PROPOSED IMPROVEMENT
TOWN OF WEST RUTLAND
COUNTY OF RUTLAND

**ADAPTIVE REUSE OF HISTORIC TRUSS BRIDGE
ALONG SIDE CLARENDON AVENUE OVER CLARENDON BROOK
PROJECT ST WALK (11)**

PLAIN ELASTOMERIC BEARINGS

REVISONS			REMARKS		
ONE PRUYNS ISLAND DR. GALLS FALLS, N.Y. 12801			RIVERSIDE FAB, INC.		
			PHONE # (1-518) 798-3533 FAX # (1-518) 798-1711		
DATE	7/31/03	PROJECT	WEST RUTLAND ST WALK (II)		
DRAWN BY	CCE	LOCATION	PEDESTRIAN BRIDGE OVER CLARENDON BROOK		
CHK'D BY			WEST RUTLAND, VT OFF VT 133		
HOUES		CUSTOMER	STATE OF VERMONT, AGENCY OF TRANSPORTATION		
BOLTS	A325	ARCHITECT	CLOUGH HARBOUR & ASSOC. LLP		
POINT	AS NOTED	JOB NO.	RFC 598		
SCALE		SHEET NAME	INSIDE ELEVATION & PLAN , RAILING		
			PRINT RECORD		
			DATE	NO.	
			DRAWING NUMBER		E1

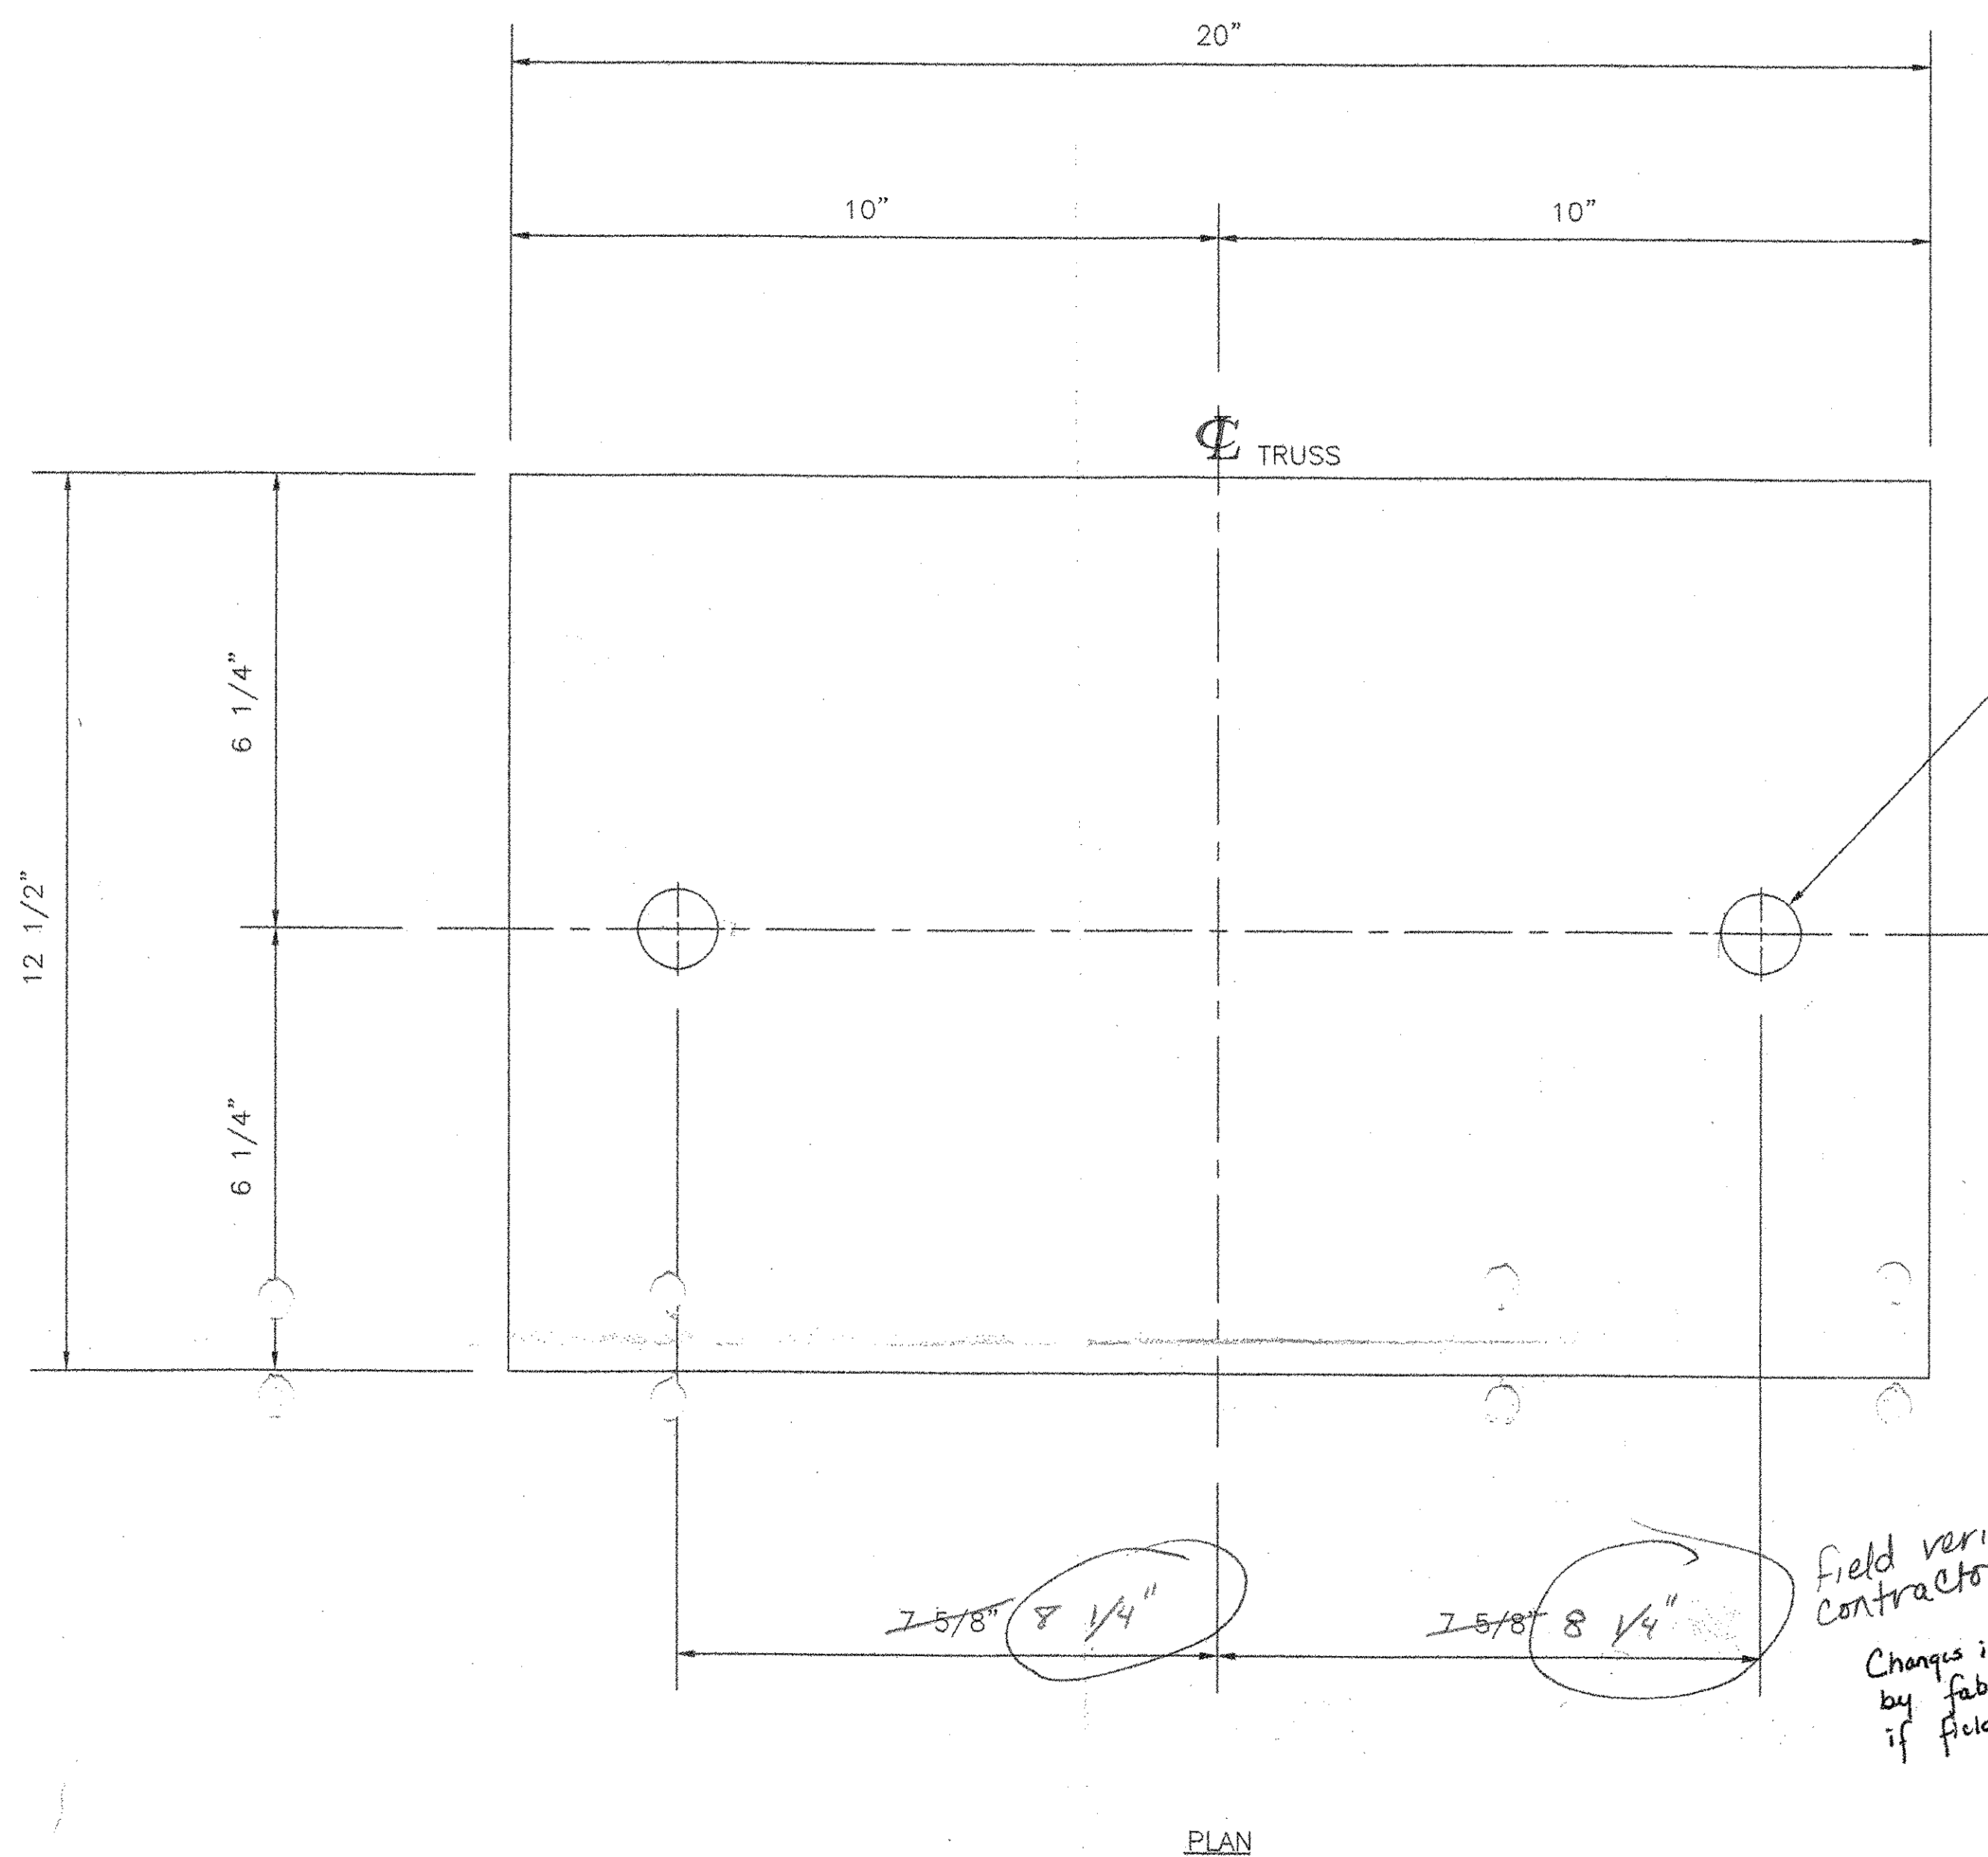
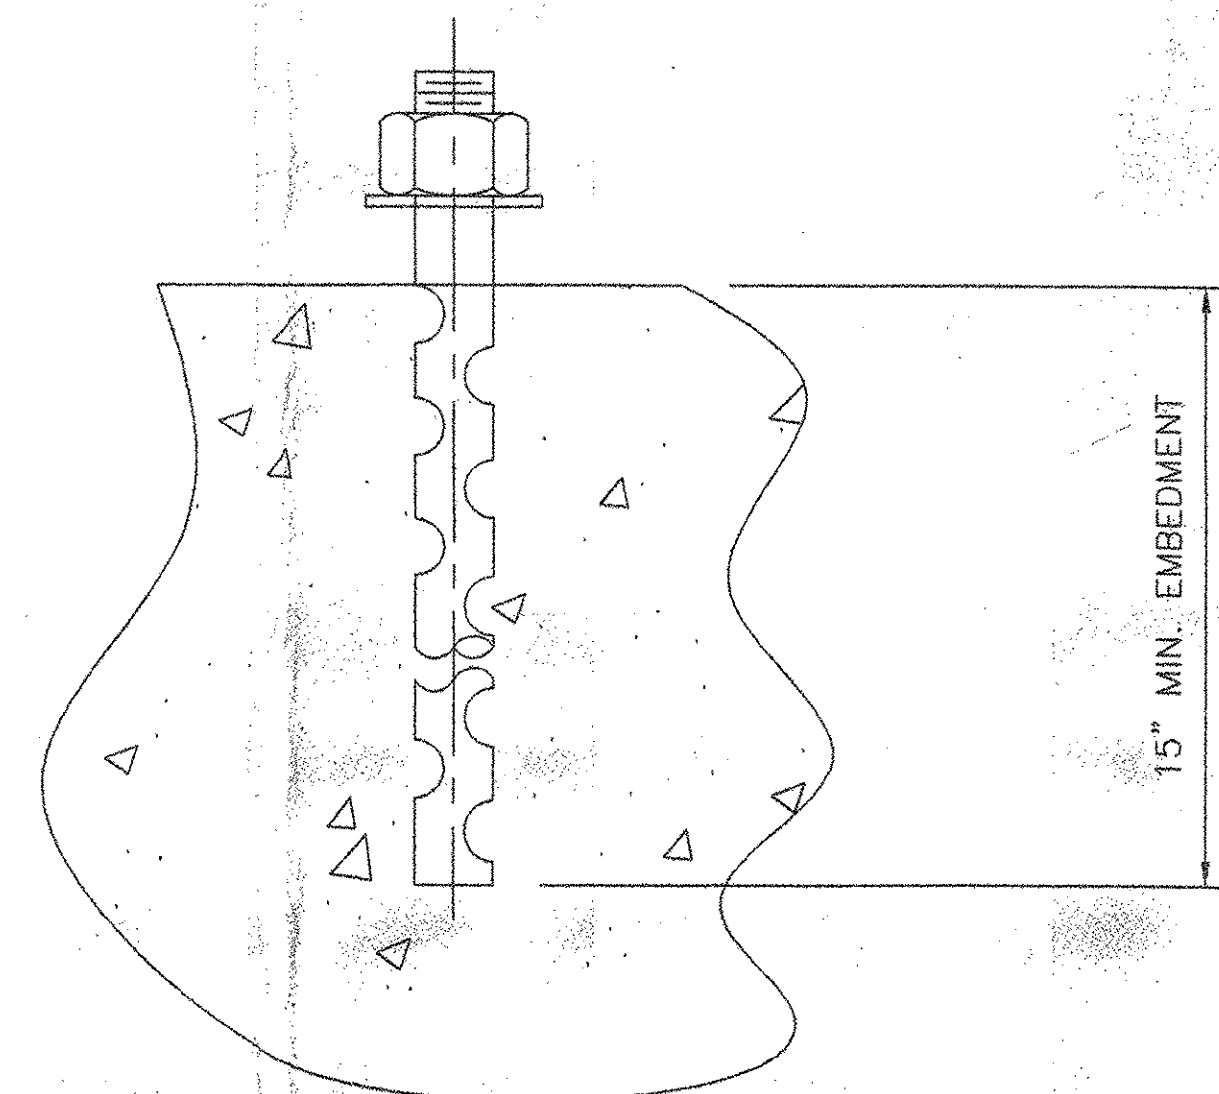
☐ NO EXCEPTION TAKEN
☐ REJECTED
☒ MAKE CORRECTIONS NOTED
☐ REVERSE AND RESUBMIT
☐ SUBMIT SPECIFIED ITEM

RESUBMIT: aw APPROVED: aw As noted
BY: aw DATE: 6/26/03

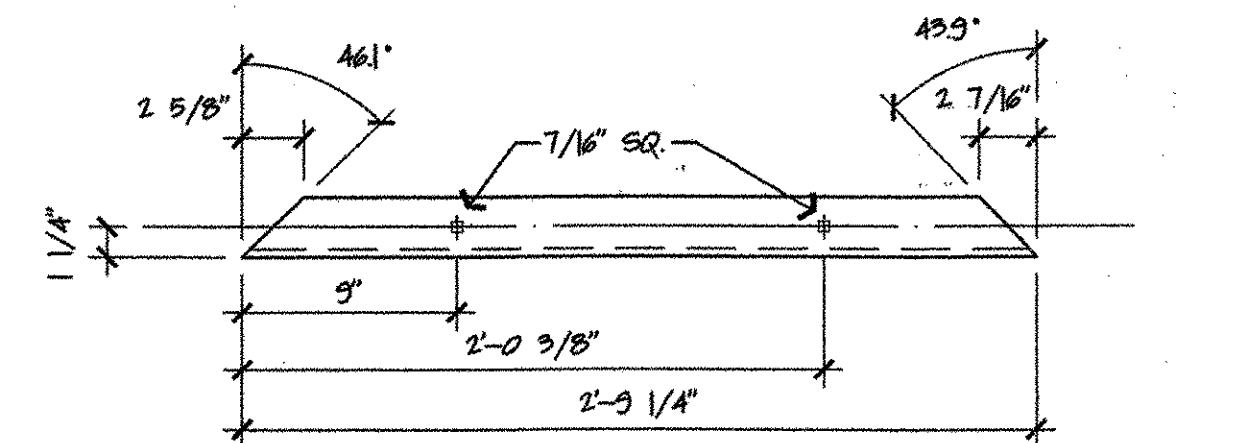
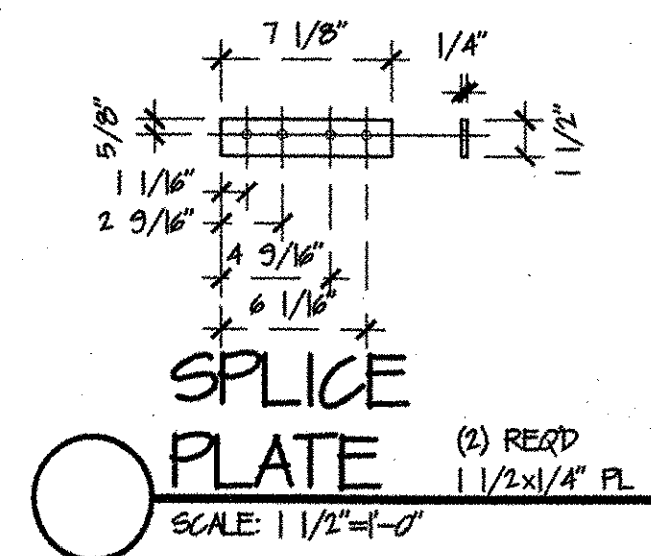
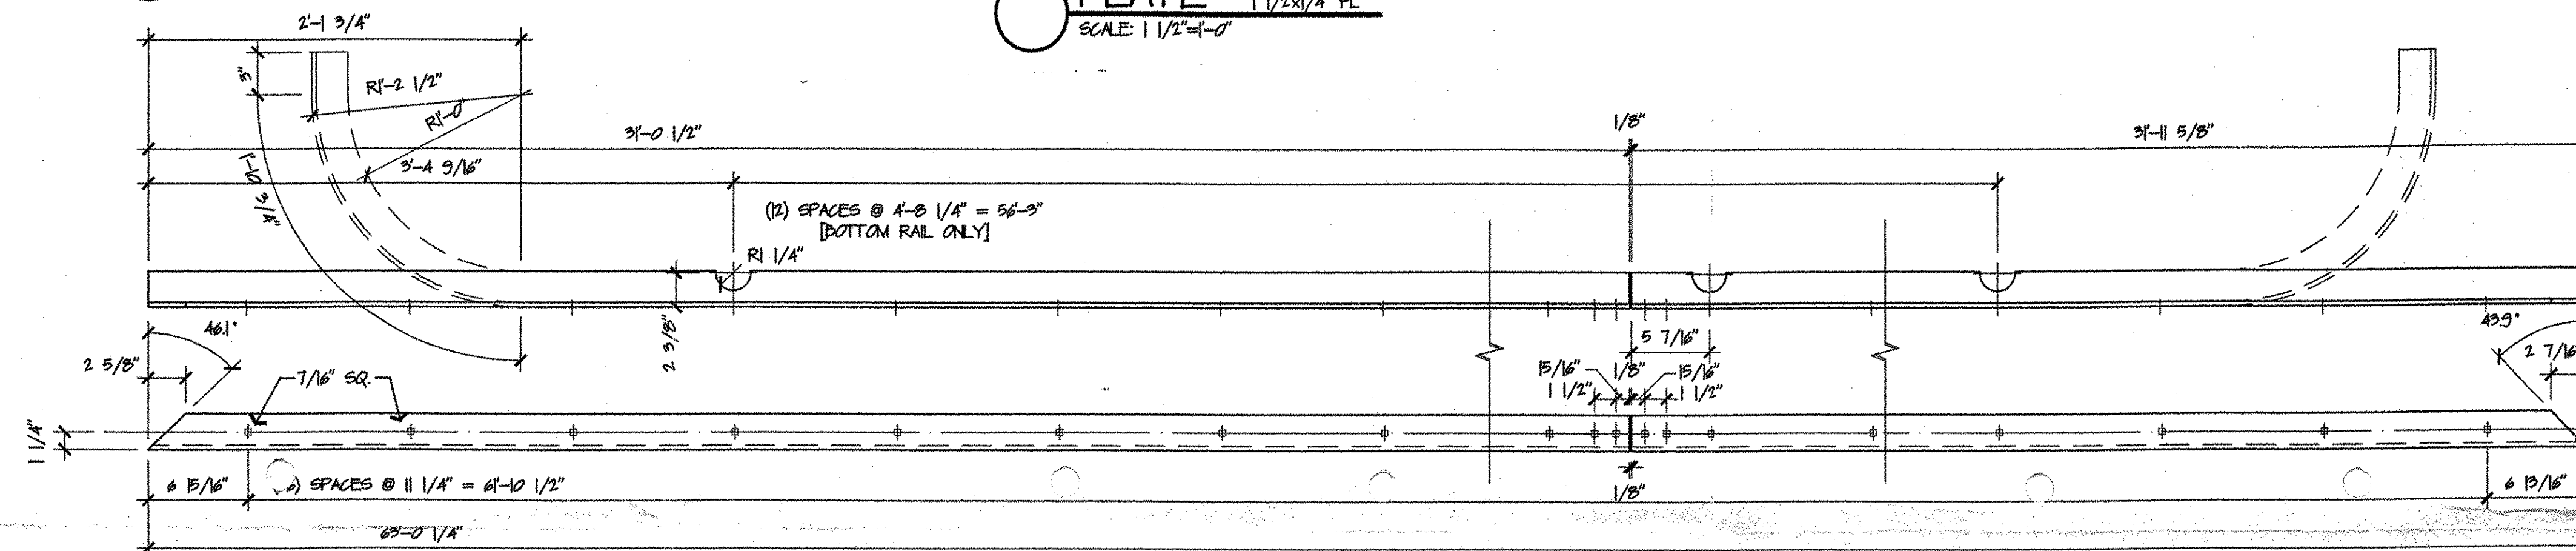
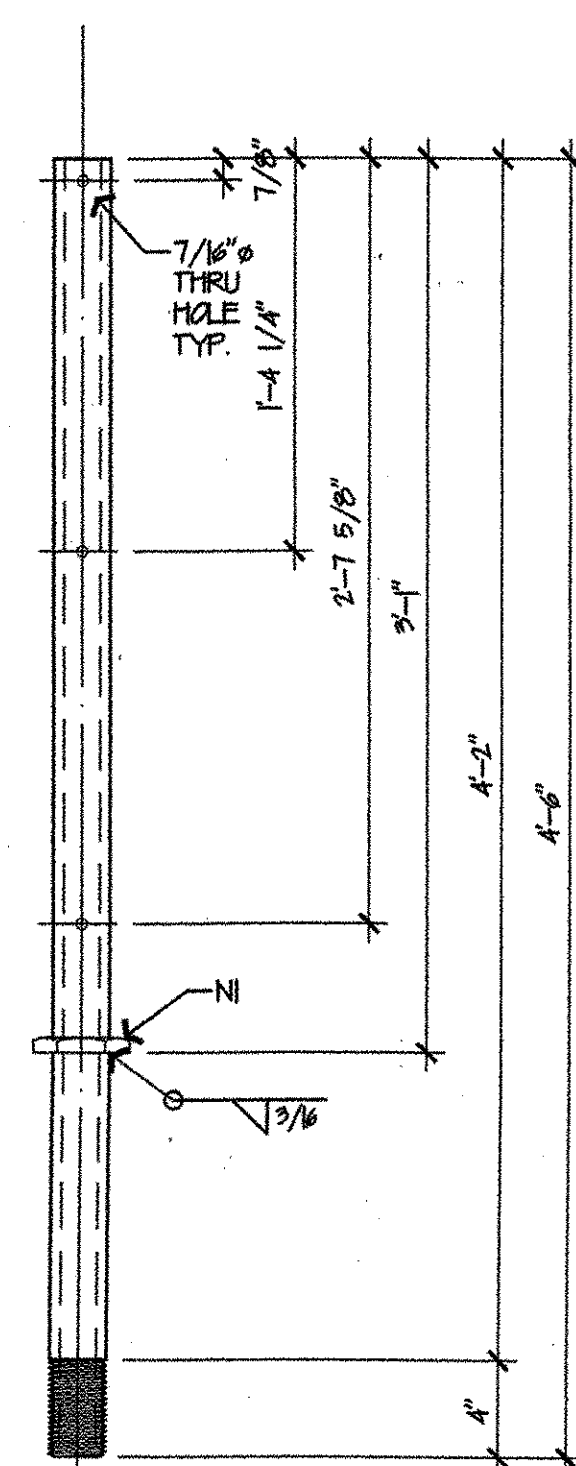
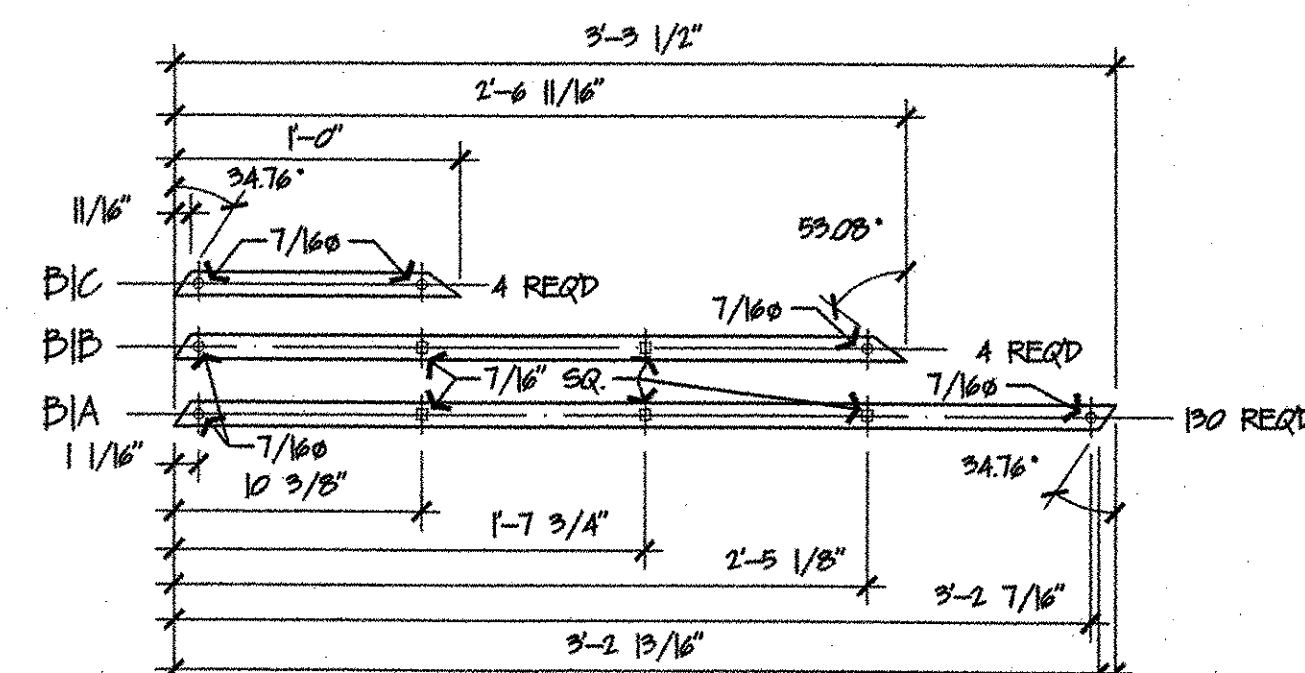
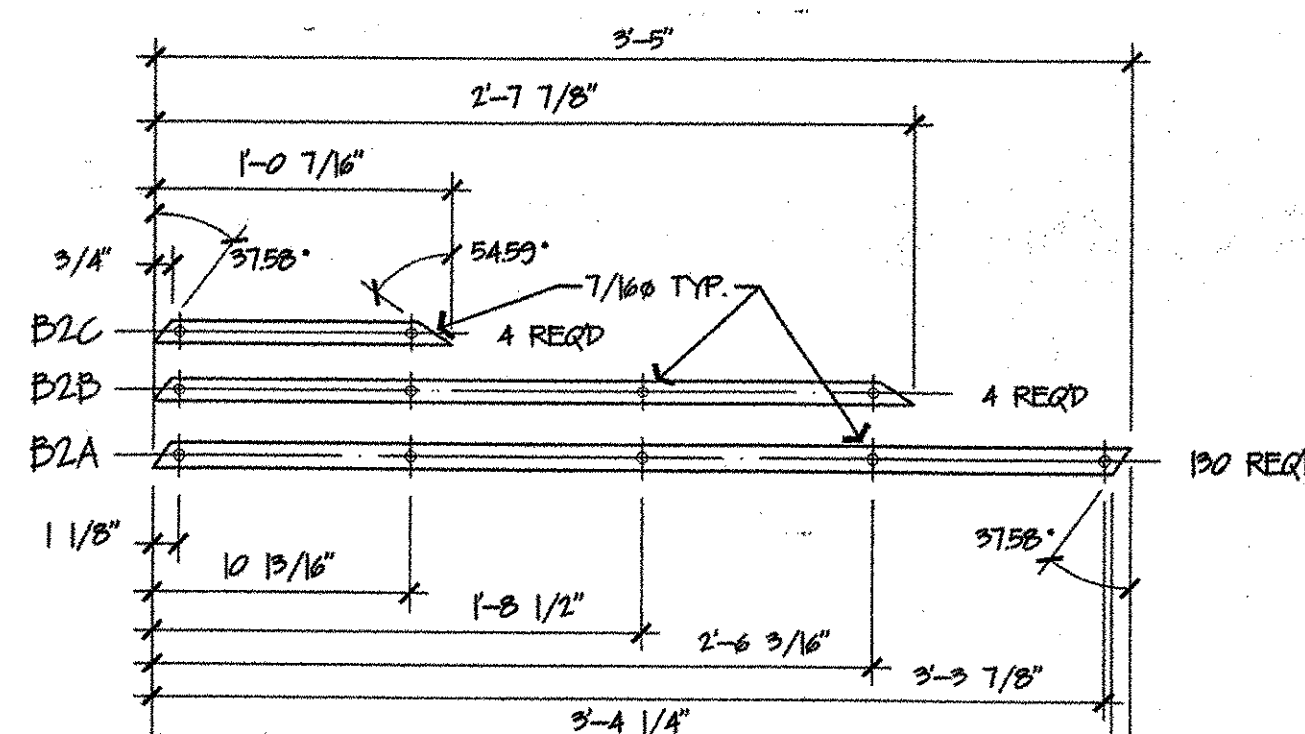
☒ NO EXCEPTION TAKEN ☐ MAKE CORRECTIONS NOTED
☐ REJECTED ☐ REVISE AND RESUBMIT
☐ SUBMIT SPECIFIED ITEM

RECEIVED
CK'D BY LH OK'D BY SES
AUG 14 2003
RESUBMIT _____ APPROVED ☒ WITH CHANGES
NOTED IN RED
BY als DATE 8/20/03
